Board of County Commissioners: 01/09/2020

PDMU-14-22(P)(R2) –TREVETA / VK TREVETA, LLC – PLN1906-0064

An Ordinance of the Board of County Commissioners of Manatee County, Florida, regarding land development, amending Zoning Ordinance PDMU-14-22(P)(R) and approving a revised Preliminary Site Plan to allow single family attached, semi-detached, and detached units in Phase 3; to increase the number of residential units in Phase 3 from 341 units to 457 units; to increase the total number of residential units from 1,103 units (300 multi-family) to 1,219 residential units (300 multi-family); to allow an increase of the multi-family building height from 35-feet to 4-stories; and revising stipulations for a project on approximately 441.3 acres that is currently zoned PDMU (Planned Development Mixed Use); generally located east of I-75 and south of 69th Street East, Palmetto (Manatee County); subject to stipulations as conditions of approval; providing a legal description; providing for severability; and providing an effective date.

December 12, 2019 Planning Commission

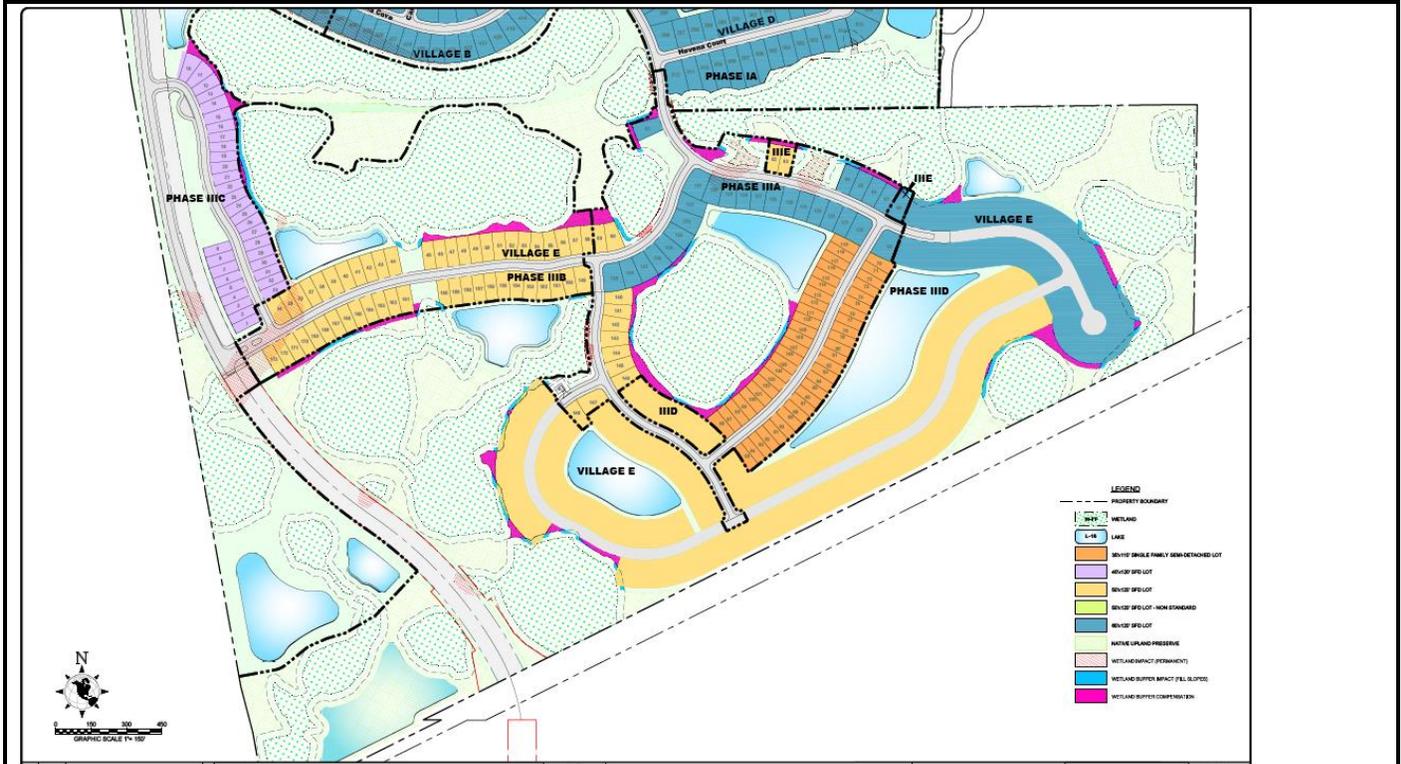
Cary Vorbeck questioned if the multifamily and townhomes would be restricted to space along I-75 and asked if this is stipulated.

Steve Strand, resident of Oakleaf Hammock, questioned the buffer area along the CSX Transportation Railroad (located south of the site).
